I reviewed the schematic for this design and here are my thoughts.

The UCC25600 seems to have 3 feedback paths in this design.

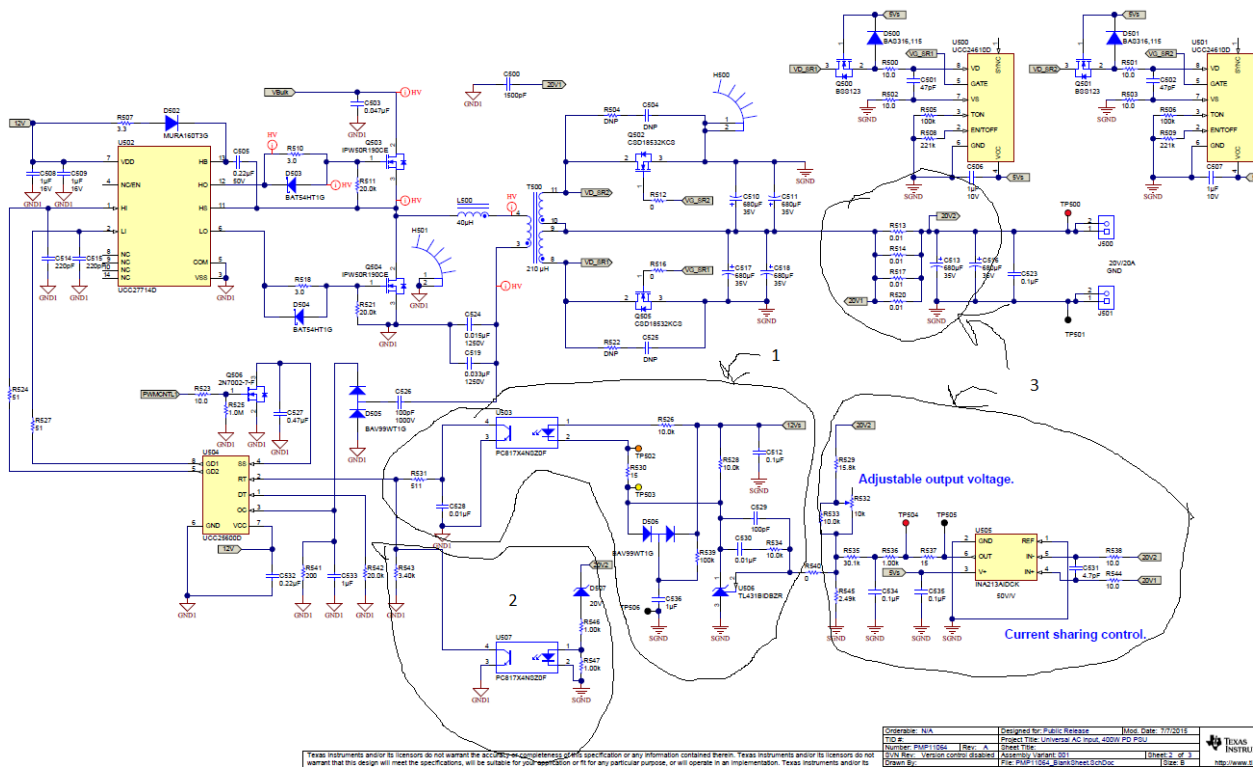
1. The 12V output I have circled all the components involved in the feedback path and numbered it 1.
2. The 20V output I have circled all the components involved in the feedback path and numbered it 2.
3. And the loading of the 20V output which is adjusted by the INA213AIDCK U505.
 - a. This device has a gain of 50 and is a shunt monitor.
 - b. I have circled all the components involved in the feedback path and numbered it 3.

These feedback paths will adjust the oscillator frequency to maintain the 12V output, the 20V output and loading of the 20V output.

1. An increase in frequency is a decrease in LLC gain.
 - a. Current decreases coming out of the UCC25600 RT pin.
2. A decrease in frequency is an increase in LLC gain.
 - a. Current increases coming out of the UCC25600 RT pin.

3. The three feedback loops will adjust the oscillator frequency based on RT current.
